Date 14 October 2024
Our Ref DS/FS24/0046
Your Ref PT\_EB/24/01015/FULL
Subject 9 Newbury Street London EC1A 7HU

LPA Reference	23/01423/FULEIA
Proposal	Demolition of the existing buildings, retention
	and partial expansion of existing basement
	plus construction of a ground, plus 73 storey
	building (plus plant) for office use (Use Class
	E(g)); Retail/food and beverage (Use Class
	E(a)-(b)); Public amenity space (Flexible Class
	E(a)-(d) / Class F1 / Sui Generis); publicly
	accessible education space and viewing
	gallery at levels 72 and 73 (Sui Generis); public
	cycle hub (Sui Generis); plus podium garden
	at level 11, public realm improvement works,
	ancillary basement cycle parking, servicing,
	plant, highway works and other works
	associated with the proposed development.
Location	1 Undershaft London EC3A 8EE
Borough	City of London
Case Officer	Gemma Delves

# PLANNING REPORT

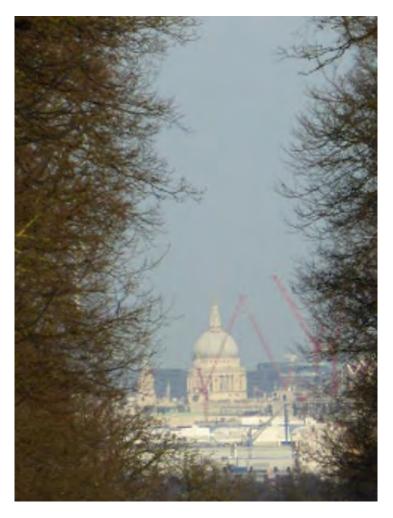
The LVMF policy of the Mayor is expressly designed to safeguard the clear skyline view of the St Pauls landmark, including the background of it. The view below is an image of the respective view and the permanent impact to that view that was done by the development of the Manhattan Lofts development, which lies in Stratford in East London, is also clear in the below image.
